Subject: TeamPoS 2000 M Motherboard BIOS

Overview

This affects the TeamPoS 2000 M Motherboard, part number 90000759 (USA0213244).

Motherboard Illustration

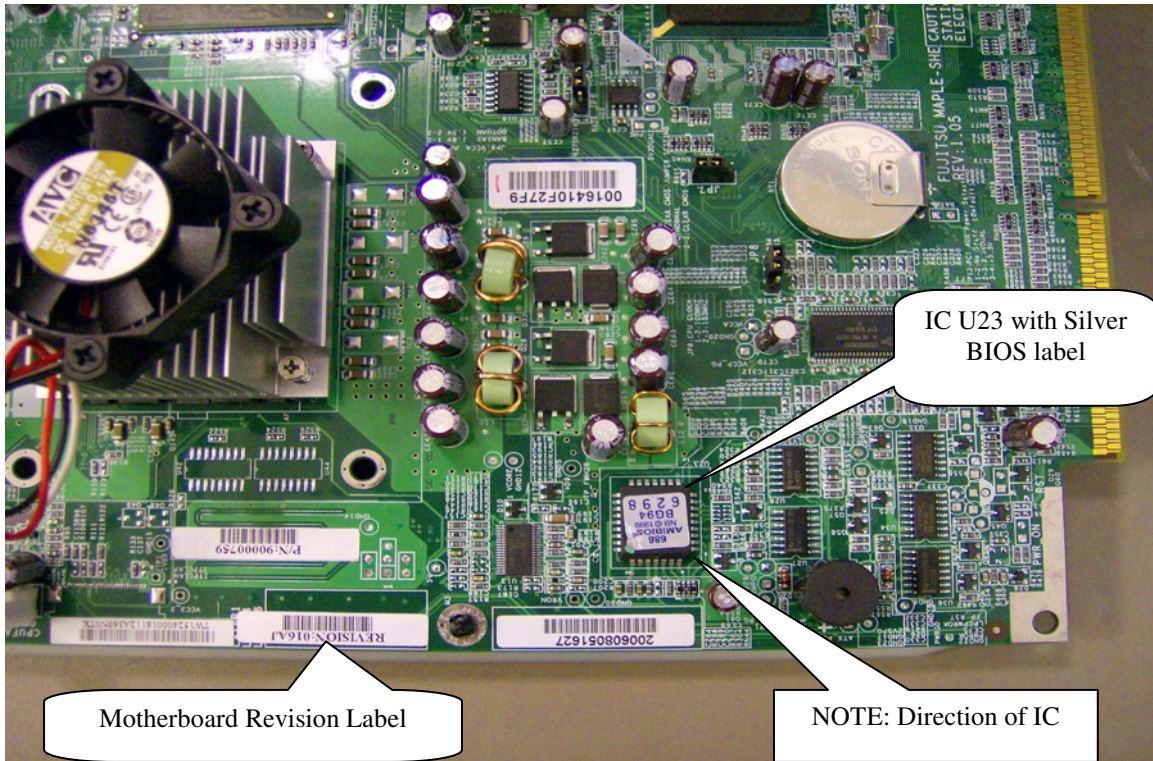
All Motherboards (90000759, USA0213244) with Revision **0021AN** the following steps must be taken regardless of the reason the board is returned or any other repairs needed, unless the board is deemed unrepairable and is being scrapped.

1. Remove the Silver BIOS label from IC U23 and save for future use
2. Check the part number on the BIOS chip:
If the chip is labeled SST 49LF004B, then do the following:
 4. Re-apply the Silver BIOS labels removed above
 5. Change the Motherboard Revision Label to be revision 0020AN
 6. Verify BIOS v44 is installed, reload if not
 7. Continue any other repairs or normal process, this board is now completed.

If the chip is labeled PM 49FL004T-33JCE, then do the following:

4. Remove (De-solder) the IC U23 from the board
5. Solder the new IC loaded with BIOS v044 onto the board, be sure to note IC orientation
6. Re-apply the Silver BIOS labels removed above
7. Change the Motherboard Revision Label to be revision 0020AN.
